Subject: Kilarc-Cow Creek Project (FERC Project No. 606)

Response to FERC Additional Information Request in Letter dated September 3, 2009

Response to AIR

Diversion maps from the 1969 Adjudication of Old Cow Creek, South Cow Creek, and
Lower Cow Creek

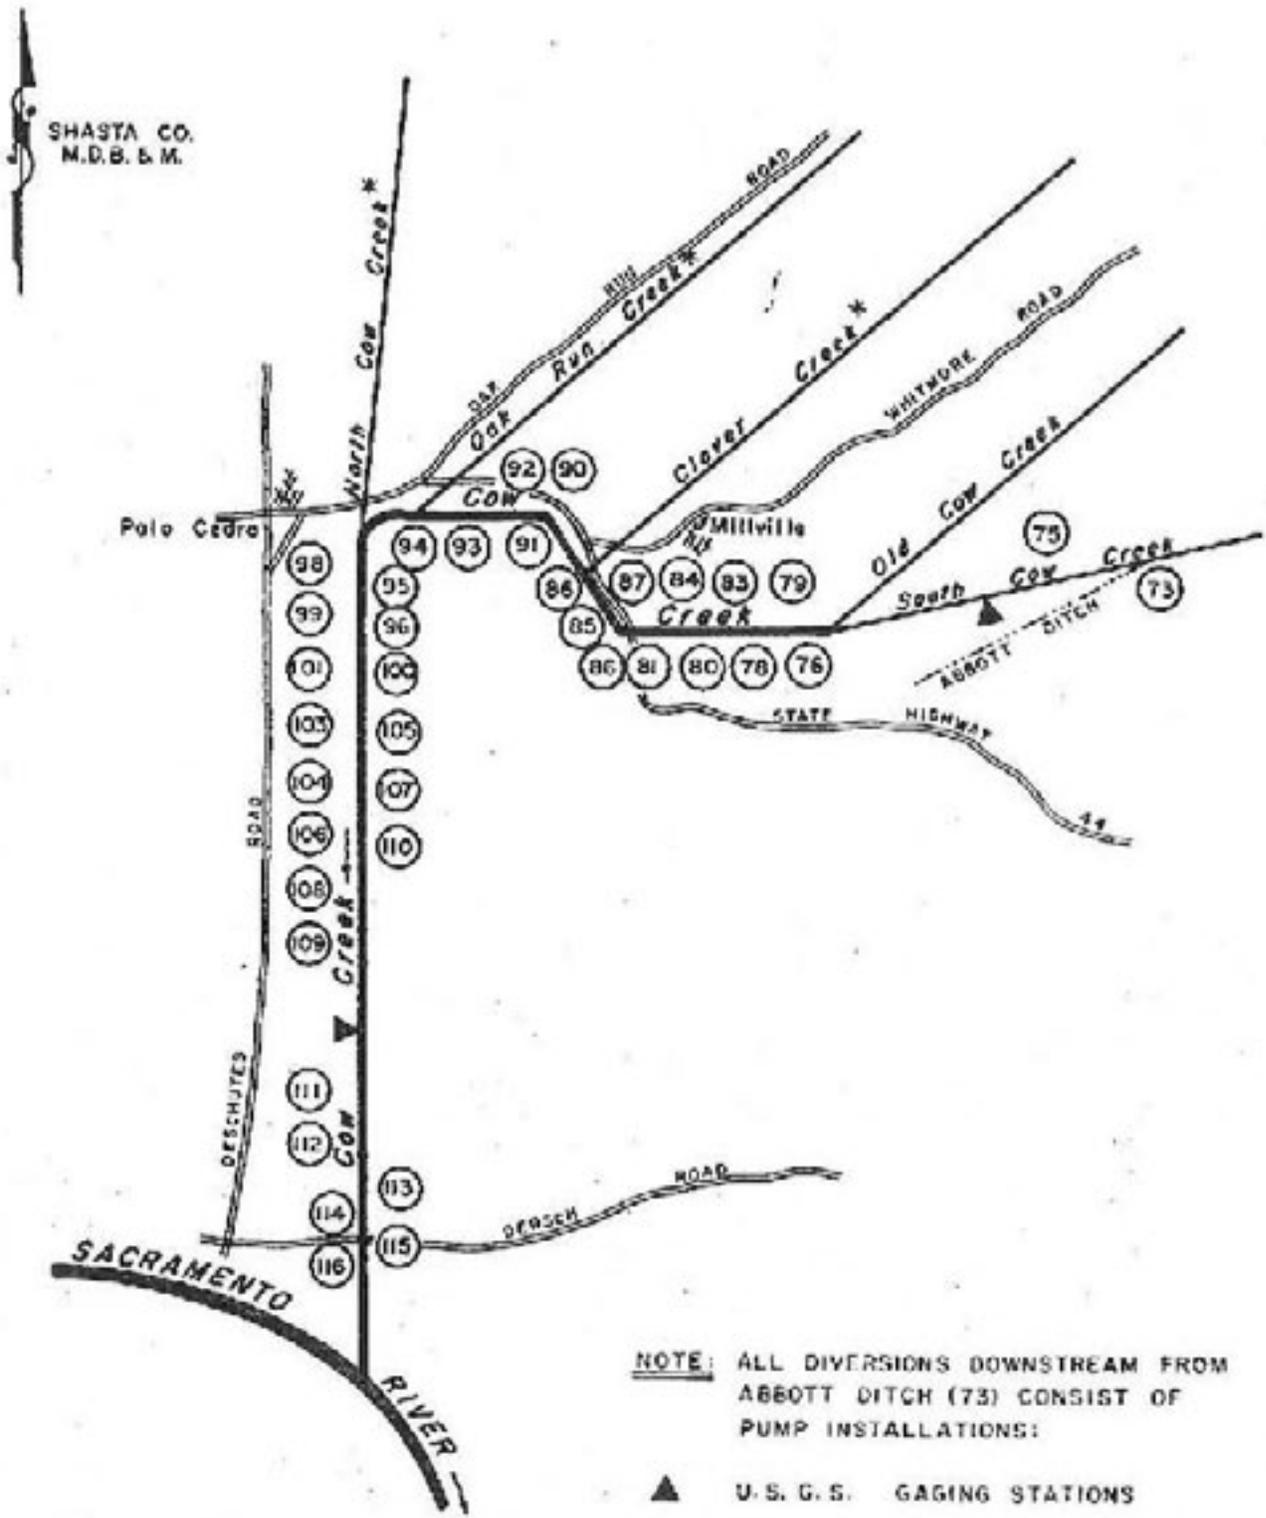
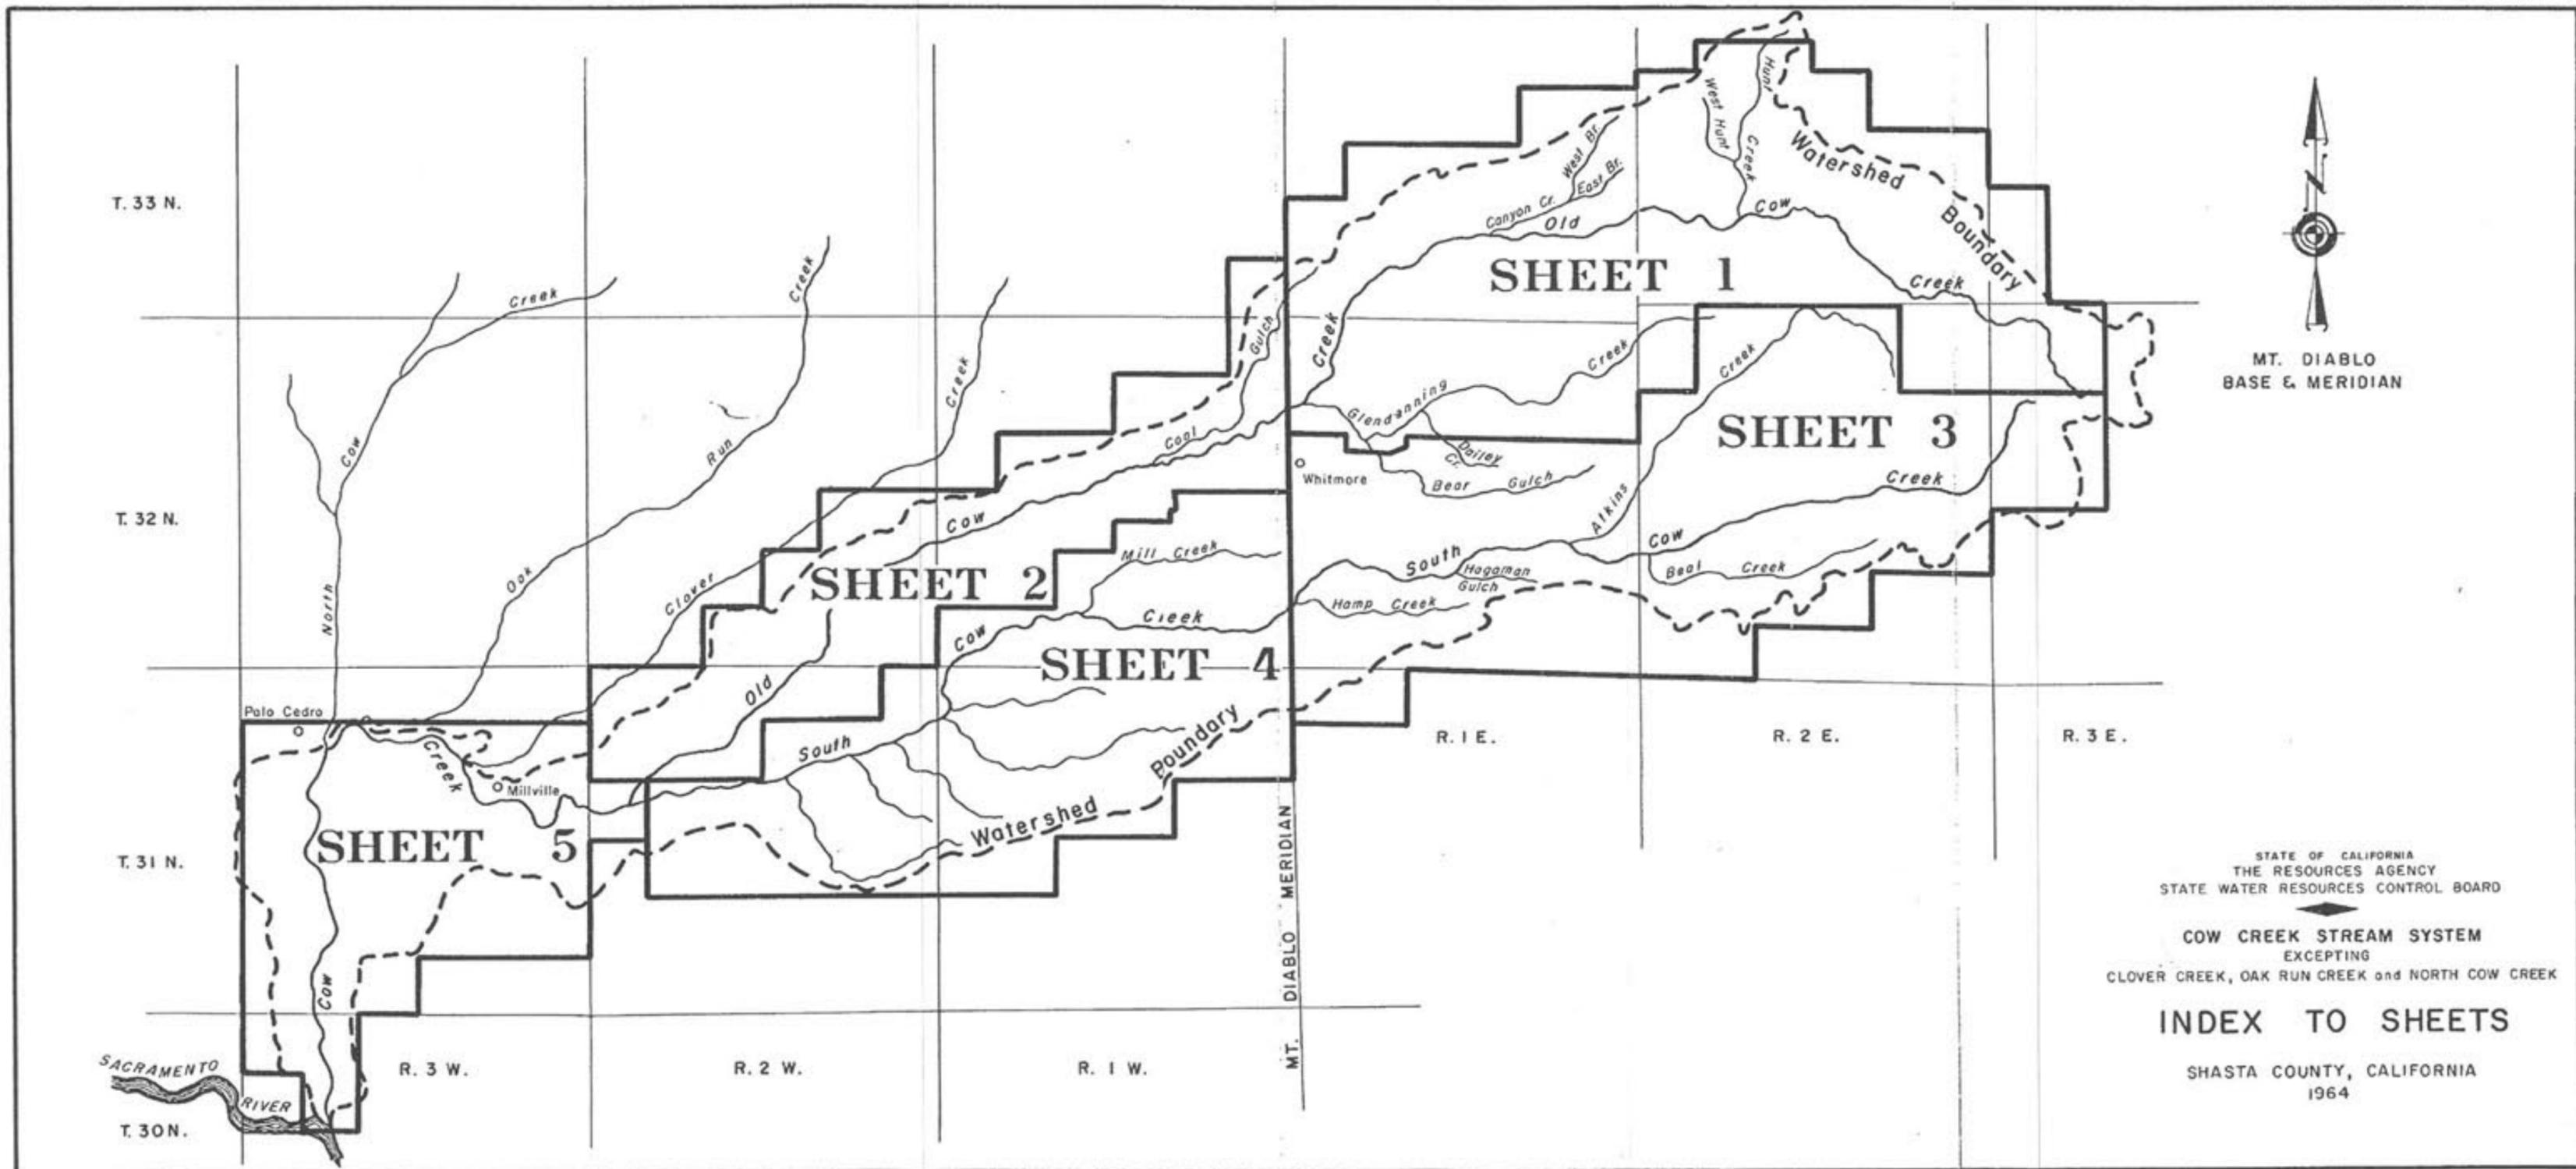
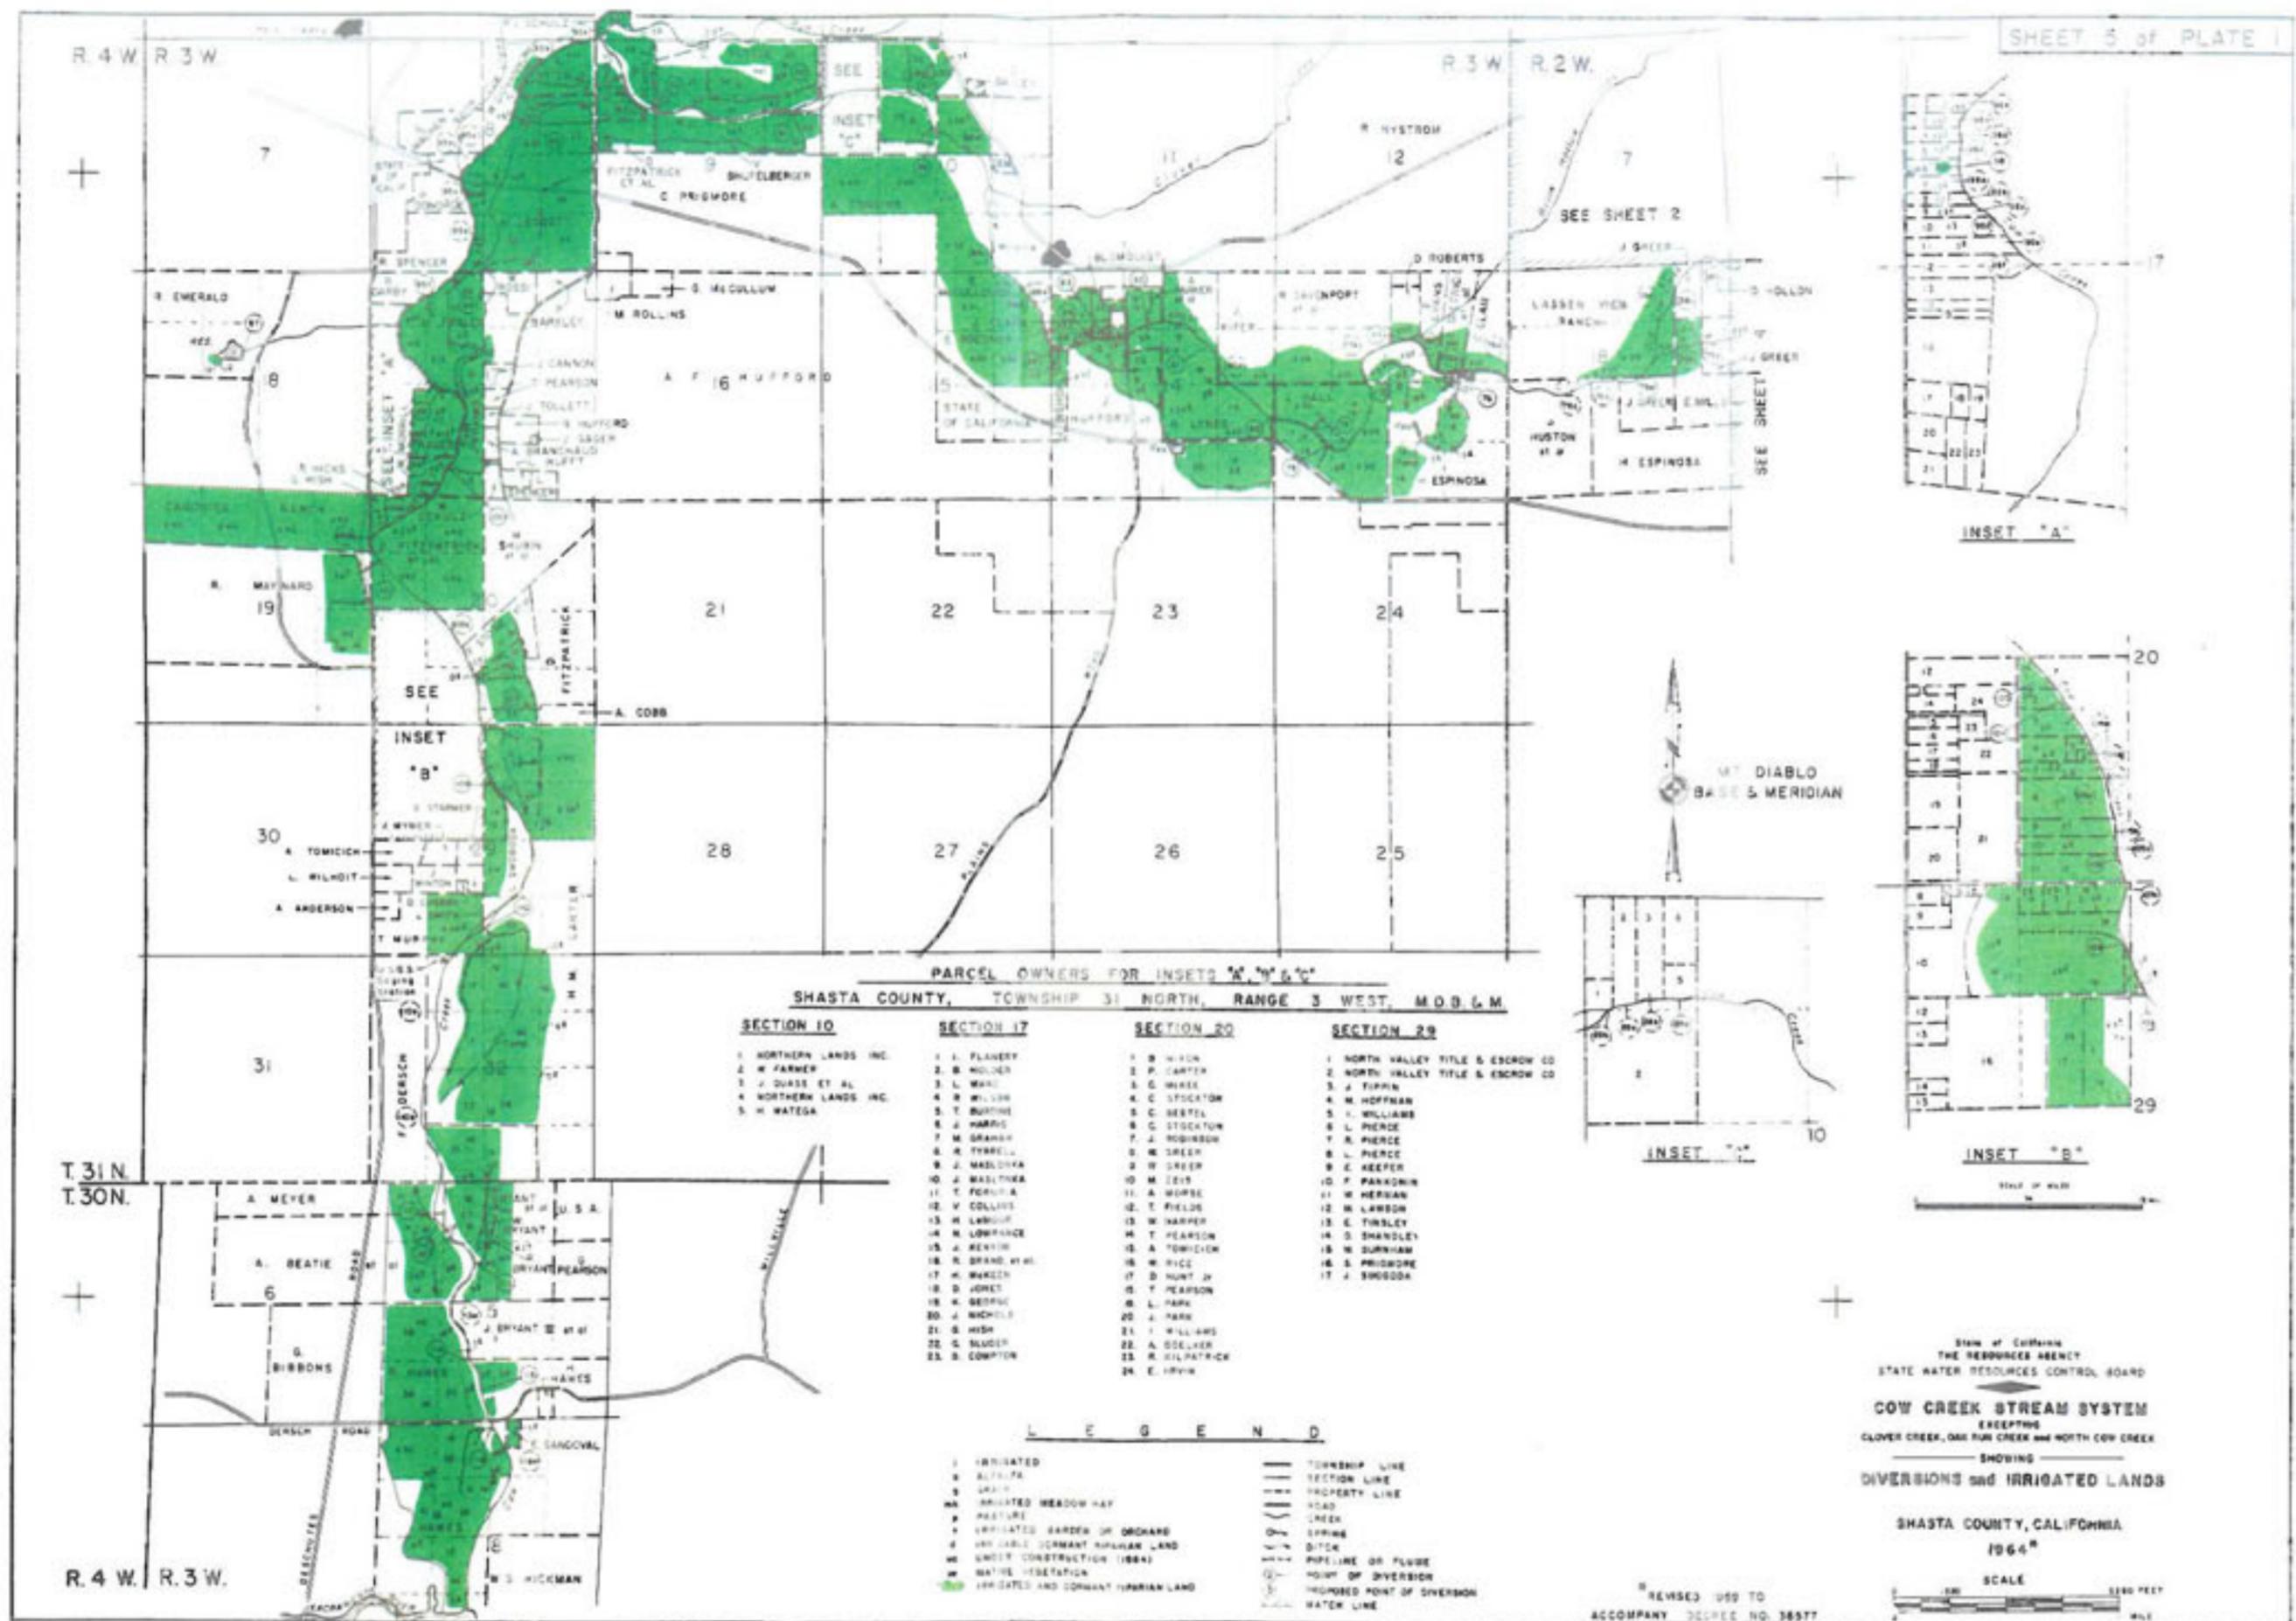
Water Resources Item 3: *Please provide a map of the Old Cow Creek and South Cow Creek basins indicating the location of other diversions and licensed or exempt hydro projects above and below the Cow Creek and Kilarc developments.*

RESPONSE – Water Resources Item 3: Attachment M contains the diversion maps from the 1969 Adjudication of Old Cow Creek, South Cow Creek, and Lower Cow Creek. See "In the Matter of the Determination of the Rights of the Various Claimants to the Water of Cow Creek Stream System Excepting Clover Creek, Oak Run Creek and North Cow Creek in Shasta County, California", Case No. 38577 (Shasta Cty. Sup. Ct., August 25, 1969). The Adjudication remains the operative document codifying water rights for the Cow Creek system.
